# Panel Decision and Report

SRP CASCC071719 – Santa Clara County, CA

May 9, 2020

**Figure 1:** Results of sensitivity analysis conducted with the South Bay regional model showing that bay water levels changed very little even when 100-year discharges for January 1983 (top) and December 1983 (bottom) storms were applied. Figures excerpted from DHI (2013)

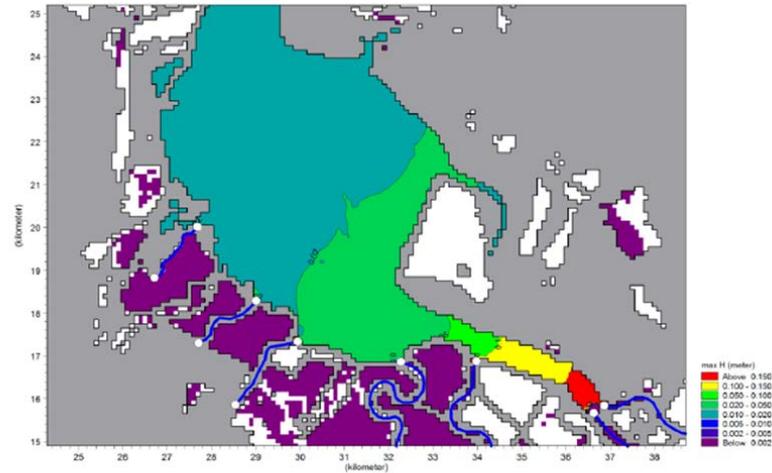
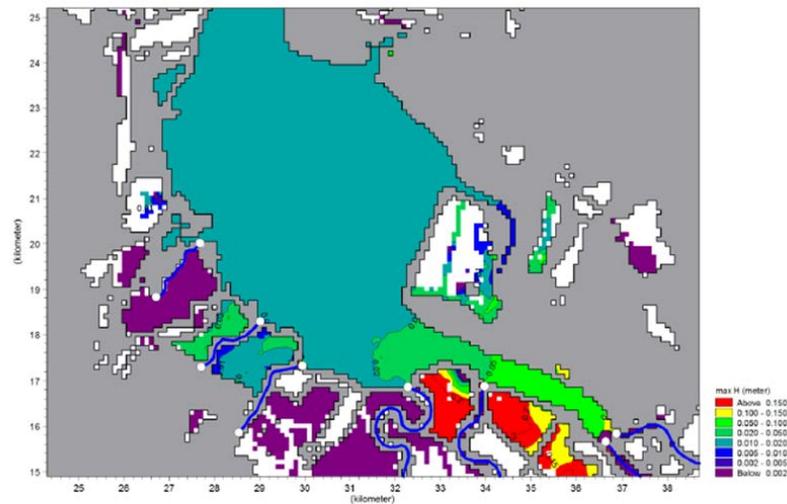
notes that the South Bay regional model (DHI, 2013) applied mean river discharges only, and it was stated in DHI's regional model report that the appropriate discharges should be applied in the local analysis (page 29 of DHI, 2013). DHI also performed a sensitivity analysis of the freshwater inflows in the South Bay as part of the regional model development and testing (page 69 of DHI, 2013). Two simulations were performed using the 100-year peak discharge for seven locations for the period of the January 1983 and December 1983 storm events. This analysis showed that the maximum difference in peak water level was less than 0.01 m in most of the South Bay as shown in Figure 1.

In Attachment A of the Appellant's request for the SRP the Appellant noted that, DHI, *together with Alameda County Flood Control District (ACFCD), performed joint analysis of river discharge versus Bay water level for Alameda Creek, where there was a long period of record available to perform the analysis. The analysis demonstrated that the joint occurrence for the 1 percent coastal level is more closely coinciding to a three to five -year river discharge. This information was presented to Baker AECOM in the final comment/response form from ACFCD, but this was submitted after the Appellant submitted its Appeal data.*

FEMA has asserted that the pairing of a five-year freshwater riverine discharge with the synthetic design storm hydrograph was not supported by the submitted documentation. The Appeal denial, dated June 21, 2019, acknowledged that the Appellant assessed the sensitivity of the large-scale regional hydrodynamic model to riverine inflows, but stated that this sensitivity analysis did not include any breaches into the former and current salt ponds. The lack of sensitivity analysis in the local model with breaching included was also noted in FEMA's March 2, 2020 response to Panel questions.

Figure 2: Water levels versus time for the January 27, 1983(upper panel), December 3, 1983 (center panel), and February 2-8, 1985(lower panel) storm events. (AECOM, 2016b)

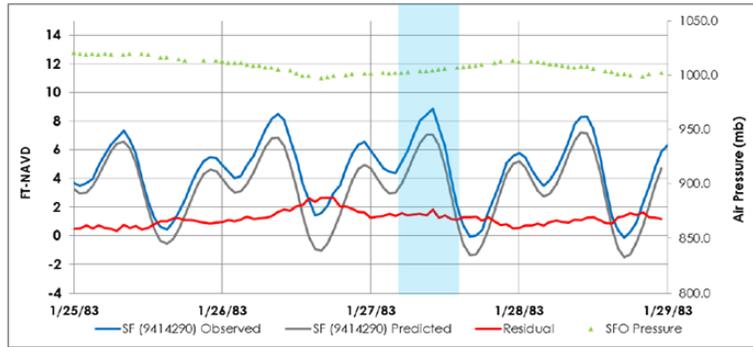
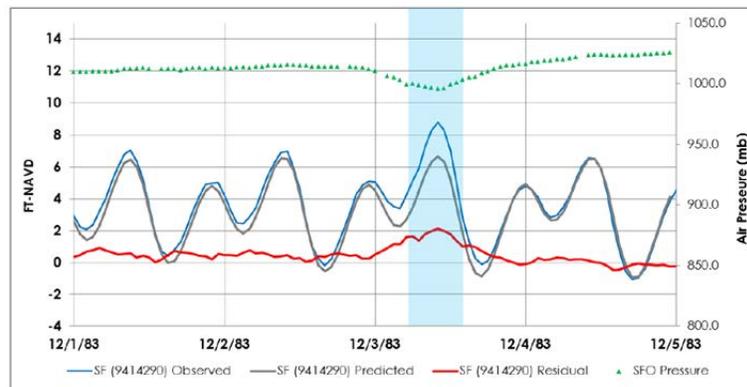
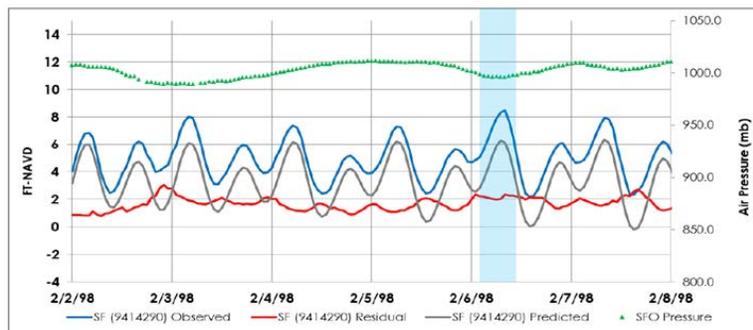
Figure 2 below shows the water level time series for the January 1983, December 1983, and February 1998 storm events: the top three storms in terms of Bay water levels. The predicted tidal water levels, in the absence of the events, are also shown. The presence of the storm event simply increases the base water level over a short period, less than half a tidal cycle, for the December 3, 1983 storm event and over multiple tidal cycles for the January 27, 1983, and February 6, 1998 storm events. The

behavior of the other top ranked flood events shows similar patterns (DHI, 2011). Figure 3 demonstrates that these three storm events gave the highest water level over the observed length of the record, with the December 1983 storm event dominating the southern part of the Bay, the January 1983 storm event dominating the central portion of the Bay, and the February 1998 storm event dominating the northern portion of the Bay.

Figure 4: Daily and extreme tidal elevation profiles in San Francisco Bay, CA (AECOM, 2016b)

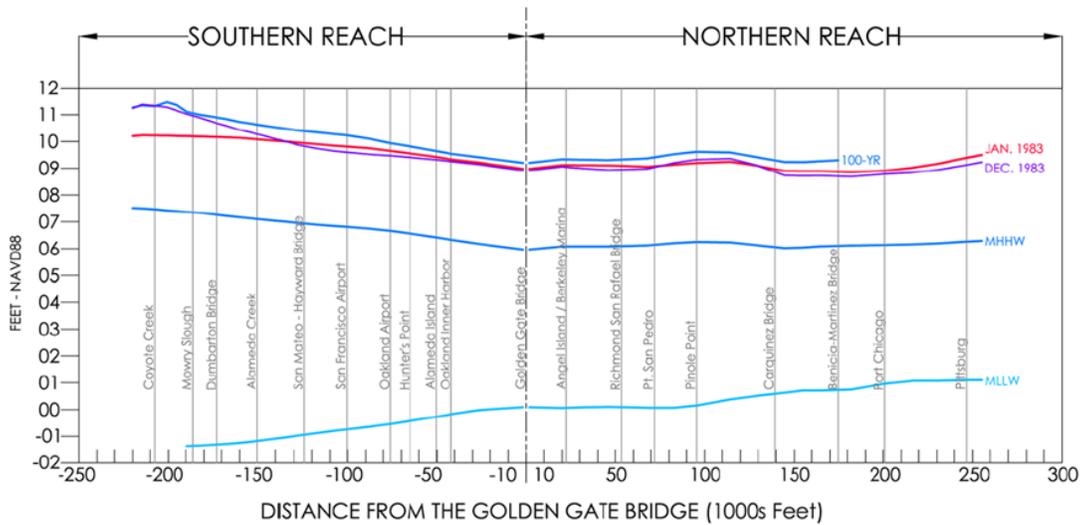
A comparison between the peak water levels for the two storm events that provide the highest water levels in the Southern Bay vs. distance along the Central Axis of the Bay is shown in Figure 4. Also shown are the Mean Higher High Water (MHHW) and Mean Lower Low Water (MLLW) levels. Finally, the estimated 100-year water levels are shown at the same transect location. The data clearly show the amplification of the tide from the entrance of the Bay to the South Bay Region, in a classic standing wave pattern. The surge from the December 1983 storm events (Figure 2, center panel) shows a similar pattern, with amplification with distance toward the south of the Bay. The January 1983 storm event (Figure 2, upper panel), on the other hand, shows almost a constant offset relative to the MHHW level. The difference between the two events is consistent with the fact that the December 1983 storm event has a duration typical of the tidal cycle, while the duration of the January 1983 storm event is several days long. Tidal theory shows that water level variations on tidal time scales should show amplification for the South Bay and those that have durations substantially longer than tidal time scales should simply result in a uniform adjustment to the water levels.

Figure 4.5 Maps of model predicted maximum water surface elevation for a high water event in January 1983. The figure on the left is the model with levees included, and the figure on the right is the model with all levees completely removed.

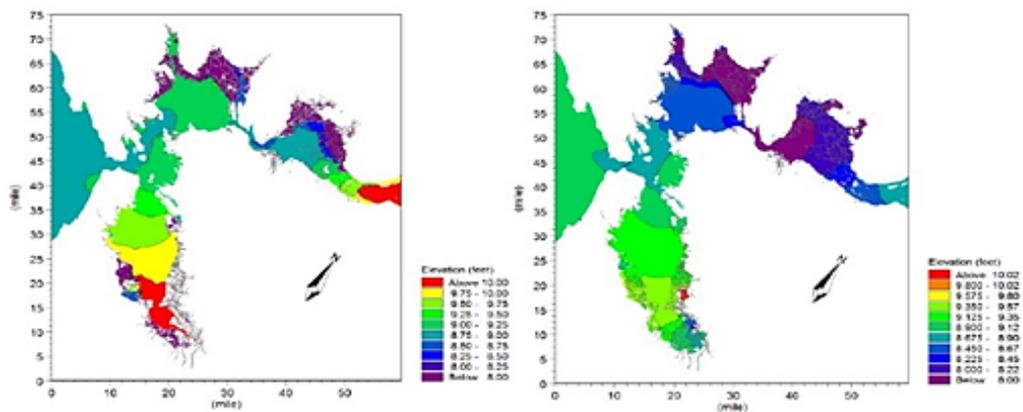
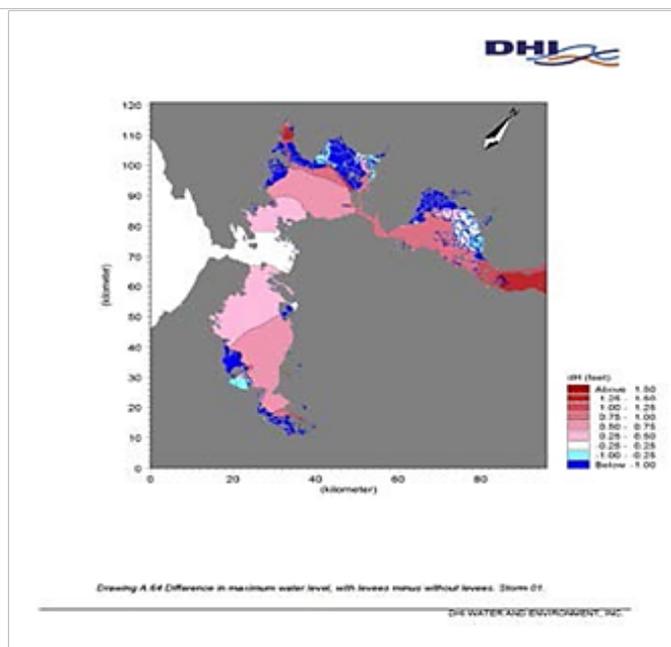
Figure 4.5, below, represents with and without levee peak water levels for the January 1983 storm and the next figure represents the difference between the two. The *without* levee case is roughly one or more feet lower than the *with* levee case.

**QUESTION/ASSERTION: How does FEMA justify assuming that all the levees function in the case for the entire Bay and when setting the boundary conditions for the Southern Bay analysis? At the same time, how does FEMA assume that the levees all fail for the South Bay and the SCVWD Appeal area?**

FIGURE 1 - LEVEE BREACH STUDY SITE LOCATIONS

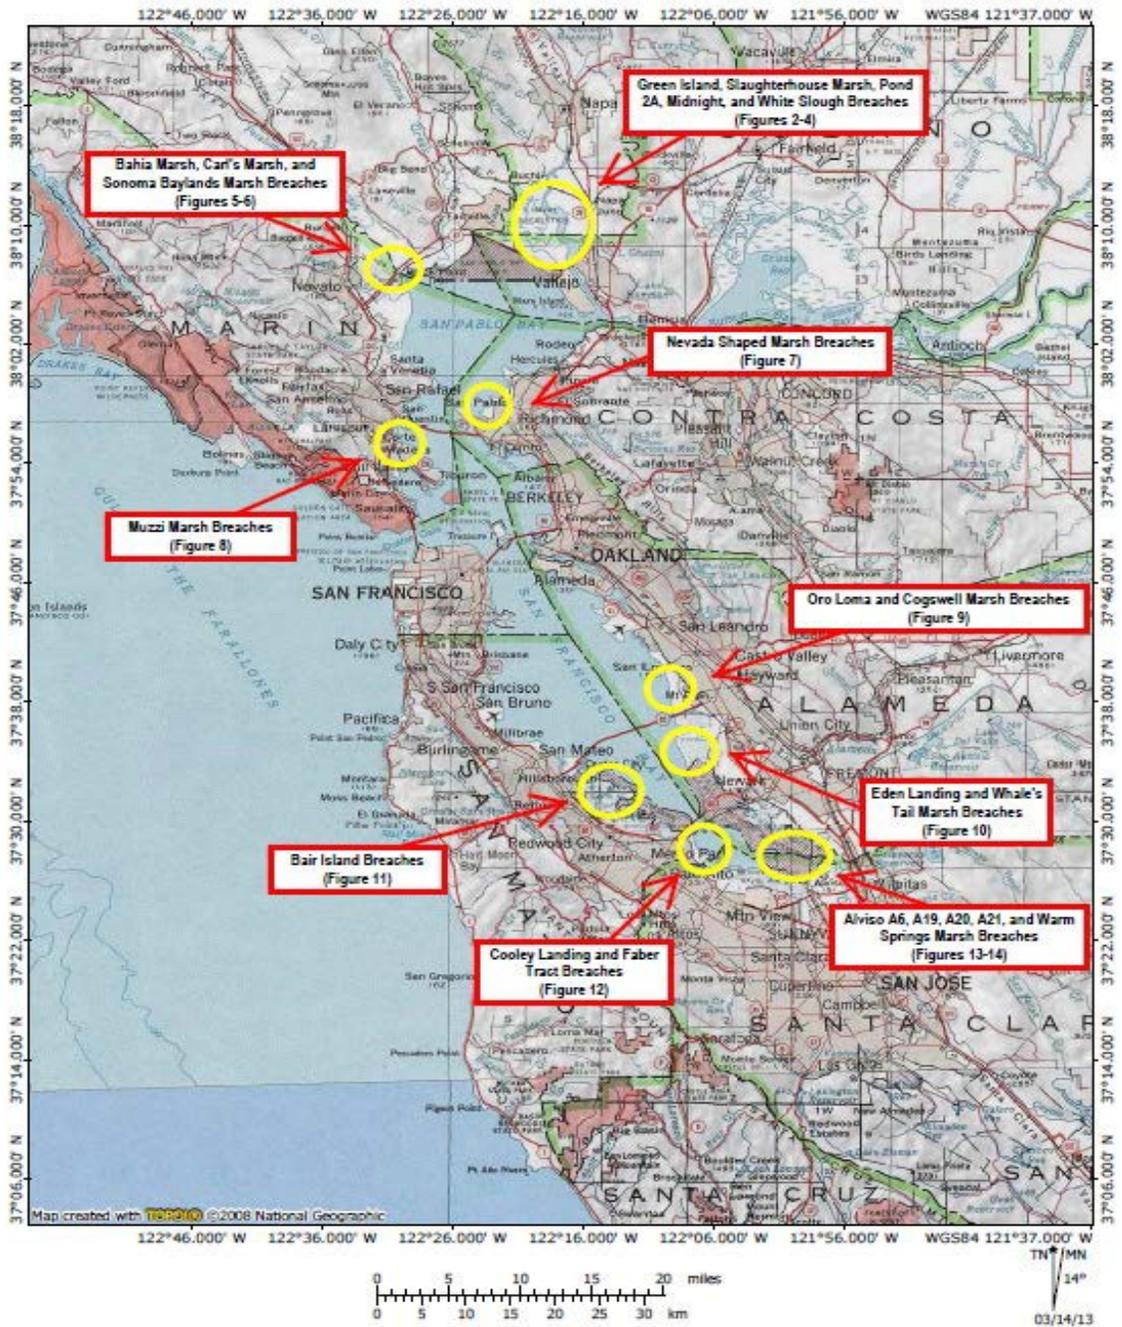
Please refer to the below figure from the *GEI Study* that shows the locations of the breached levees.

In this case of comparable breach locations, and as noted in the caption of the table, are evaluated in the vicinity of Eden Landing (see figure above) representing the Southern portion of the Bay.

**QUESTION/ASSERTION:** *Given this information, isn't DHI's selection of 100 ft reasonable to represent the average width for all levee breaches? (125 ft + 86 ft + 86ft = 266 ft/3= 92 ft)? And for a range in the levee sensitivity study of 50 to 200 ft?*

Figure 3.24 Difference in peak water levels (in meters) applying the 100-year South Bay discharges minus baseline simulation. December 1983 storm.

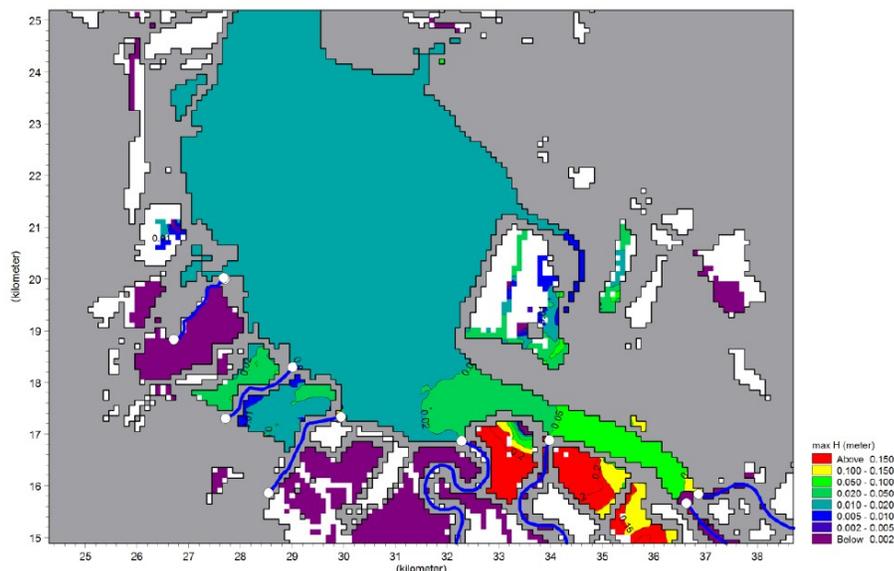
In an earlier study, **DHI (2013)** performed a sensitivity study for freshwater input to the South Bay Area and showed that the 100-year freshwater input resulted in very small changes in the peak water levels. Changes (shown in *Figure 3.24*, below) were generally quite small and typical of uncertainties in the model validation.

**QUESTION/ASSERTION:** *Doesn't this analysis support the idea that even if 100-year freshwater discharges are correlated with the 100-year surge event, that the impact of them is quite low in this area with complex topography? Is it not the case that if levees were breached, that changes in water elevation would be even lower than estimated since the river discharge would be distributed over a wider area?*

Figure 4.5 Maps of model predicted maximum water surface elevation for a high water event in January 1983. The figure on the left is the model with levees included, and the figure on the right is the model with all levees completely removed.

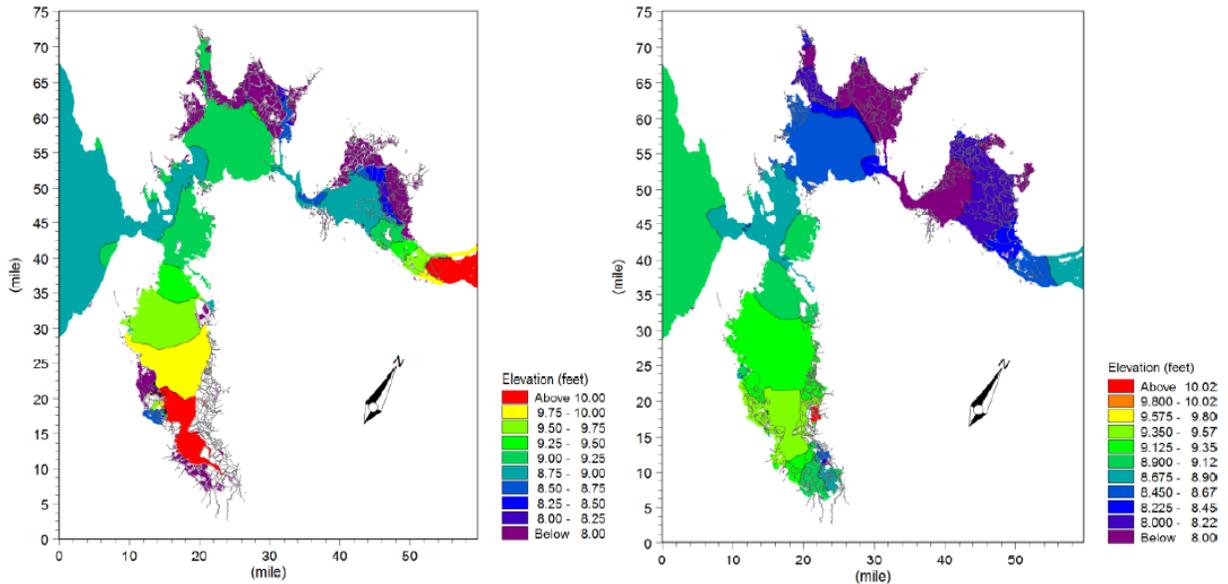
*SRP Question: (a) How does FEMA justify assuming that all the levees function in the case for the entire Bay (b) and when setting the boundary conditions for the Southern Bay analysis? At the same time, (c) how does FEMA assume that the levees all fail for the South Bay and (d) the SCVWD Appeal area?*

The regional hydrodynamic modelling that provides the input to the one-dimensional WHAFIS and wave-runup analyses assumes the pond berms and non-levee embankments remain intact (as shown on the left in Figure 4.5, DHI 2011). The sensitivity analysis shown in DHI’s report (2011) with all pond berms removed from the model (shown on the right in Figure 4.5, DHI 2011) was not specifically requested by FEMA. This sensitivity analysis was completed by DHI to highlight the importance of retaining the pond berms in the regional San Francisco Bay model. Having this simulation represented in DHI’s report (2011) has led to significant stakeholder confusion throughout the FEMA San Francisco Bay Area Coastal Study process as to how FEMA treats non-levee embankments and pond berms.

The pond complexes in the North and South Bays include extensive storage areas that would reduce Bay water levels if all pond berms and non-levee embankments were removed at once, as reflected in Figure 4.5 on the right. However, removing all pond berms entirely in the simulation represents an extreme and unrealistic situation that would not occur in nature. This assumes the pond berms would disappear in their entirety if they were to fail. However, pond berms, non-levee embankments, and levees generally fail at specific weak points along a reach. Predicting the exact timing and location of a breach is not possible unless it is a specific design feature of the system (FEMA 2013).

Regardless of the mode or location of pond berm failure, the majority of the structures would remain in place. Therefore, the simulation completed by DHI (2011) and shown on Figure 4.5 on the left with all pond berms intact provides a more accurate depiction of what the Bay water levels would be when pond berm failures occur. The model output from the scenario shown on Figure 4.5 on the left (pond berms intact and represented in the regional hydrodynamic model) was used as input to the FEMA one-dimensional coastal analysis, including overland wave propagation and wave-runup calculations, for the North and Central Bays.

Figure 4.14 Approximate 1% SWEL along Transect 4 for the 3 breach widths. The blue line is 50 foot breach widths, red is 100 foot breach widths, and green is 200 foot breach widths.

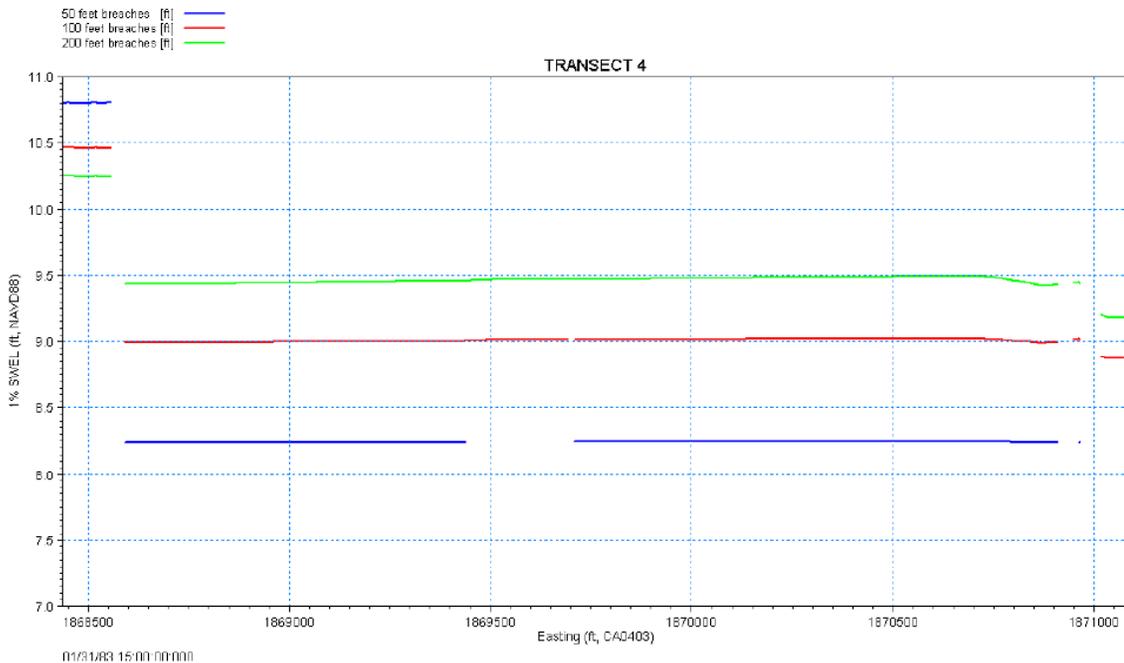
**QUESTION/ASSERTION: Why does this analysis not meet FEMA requirements for sensitivity testing for breach width? As to breach number and location, did not DHI's analysis address the worst case, with regard to breaching, since they assumed all levees were breached?**

The Appellant completed sensitivity analysis with 50 foot, 100-foot, and 200-foot breaches and compared the water levels in the ponds (DHI 2016). Figure 4.14 from DHI (2016) shows that as the breach width is increased, the water level elevations within the ponds increase, and the water level elevations on the outboard side of the breach decrease. However, it is not clear if the above requirement for no significant change in flood elevations was met the sensitivity analysis presented in Figure 4.14 from DHI (2016). In addition, the selection of a 100-foot breach over the 200-foot breach is not supported if the intent of the modeling effort is compliance with the Structural Based Inundation Procedure.

Figure 3-1. New Levee Analysis and Mapping Process

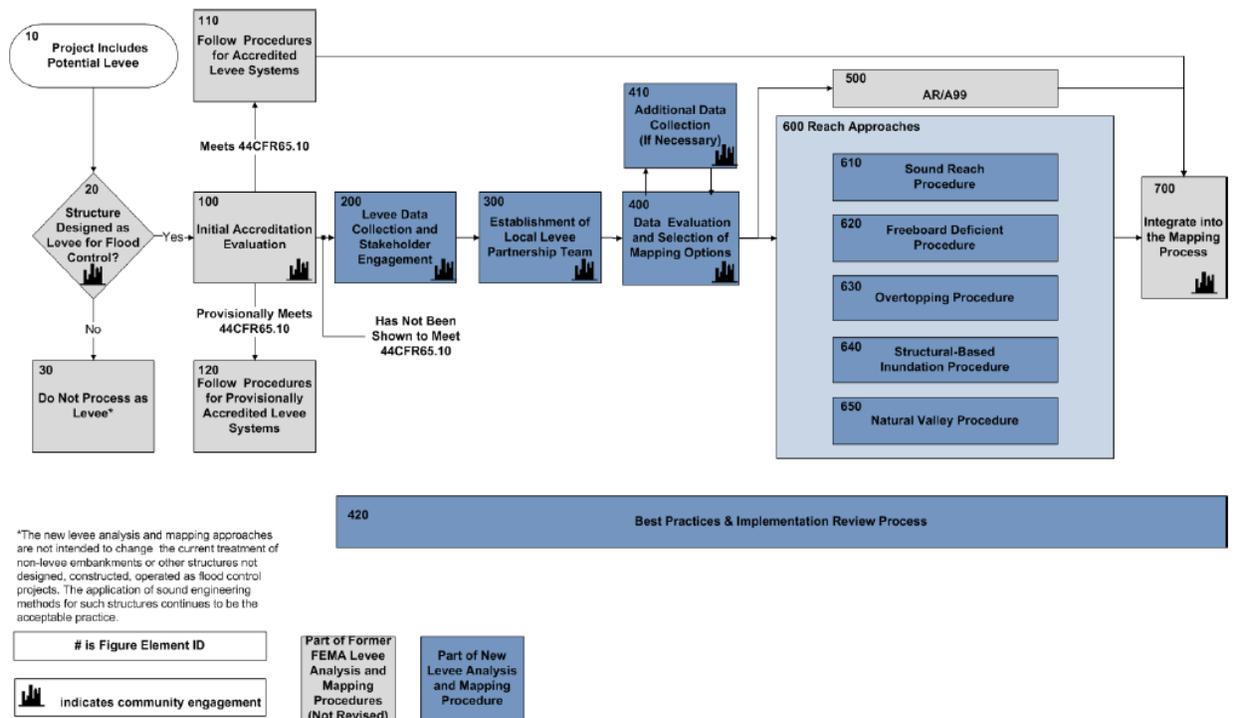
***QUESTION/ASSERTION: Why FEMA did not give any consideration to LAMP Policy when they chose to follow the without levee approach in their Flood Study?***

Figure 3.1 from FEMA (2013) highlights the process for following the *Analysis and Mapping Procedures for Non-Accredited Levee Systems*. If a structure was not designed as a levee for flood control, item 30 notes “do not process as a levee”. Figure 3.1 further notes:

*“Non-accredited levees subject to coastal flood forces will be fully intact within the storm surge model setup to determine peak storm-surge elevations seaward of the levees. In these situations, consideration will be given as to how the levee system will impact wave propagation. A steady-state condition will then be assumed landward of the levee, and the 1-percent-annual-chance WSEL will be extended landward of the non-accredited levee until it intersects the ground elevation, or the levee on the opposite side, in the case of a ring levee.” page 4-20, FEMA (2013)*
